8-28-80  
ML-2

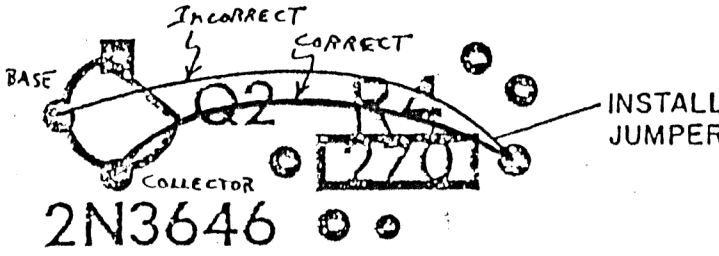
Mod#	ECO#	Date Issued	CHANGE	REASON
1	235	5-7-80	Rewire 2 sections of IC15 (74LS175) per marked print. (See ECO, p.2) Change IC44 from an S374 to LS374. Change IC15 from 74LS175 to 74175.	Reduces clock rate on state logic to improve high temp operation and allow for propagation delays.
2	392	8-28-80	Change R2 from 560 $\Omega$ to 220 $\Omega$ and R5 from 560 $\Omega$ to 220 $\Omega$ . Change C1 from 47pf mono to 100pf mono and C10 from 100pf mono to 220 pf mono. Change IC7 from 74LS00 to 74S00 and IC65 from 74LS11 to 74S11.	Interaction with 64KZ Rev.J caused <u>INVALID JUMP'S</u> to occur, because <u>MEMDISABLE</u> was being released too late. This change speeds up the <u>MEMDISABLE</u> circuit on the 48KTP by 22 nsec.

Mod#	ECO#	Date Issued	CHANGE	REASON
1	392	8-28-80	Change R2 from 560 $\Omega$ to 220 $\Omega$ and R5 from 560 $\Omega$ to 220 $\Omega$ . Change C1 from 47pf mono to 100pf mono and C10 from 100pf mono to 220pf mono. Change IC7 from 74LS00 to 74S00 and IC65 from 74LS11 to 74S11.	Interaction with 64KZ Rev.J caused <u>INVALID JUMP'S</u> to occur, because <u>MEMDISABLE</u> was being released too late. This change speeds up the <u>MEMDISABLE</u> circuit on the 48KTP by 22 nsec.
2	545	1-16-81	1. Remove C24 (22pf mono capacitor). 2. Replace R6 (270 ) with a wire.	To provide compatibility with PAL ver- sion of the SDI board set.

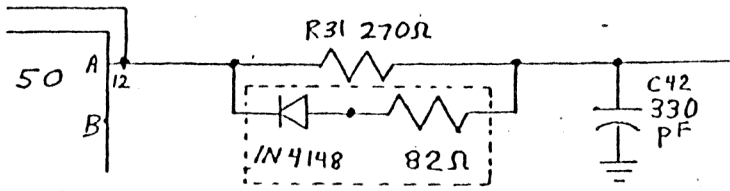
Mod#	ECO#	Date Issued	CHANGE	REASON
7	513	12-10-80	PCB Assy: Delete- Q5 2N3646 transistor 009-0000 R16 1 KOHM resistor 001-0018	These components are part of the pRDY circuit which has been eliminated.
8	514	12-10-80	On solder side: Jump IC41-10 → IC56-2, Cut trace between IC56-2 & IC37-8, next to IC56-2.	This changes the "STAT FULL" bit from hardware to software control.
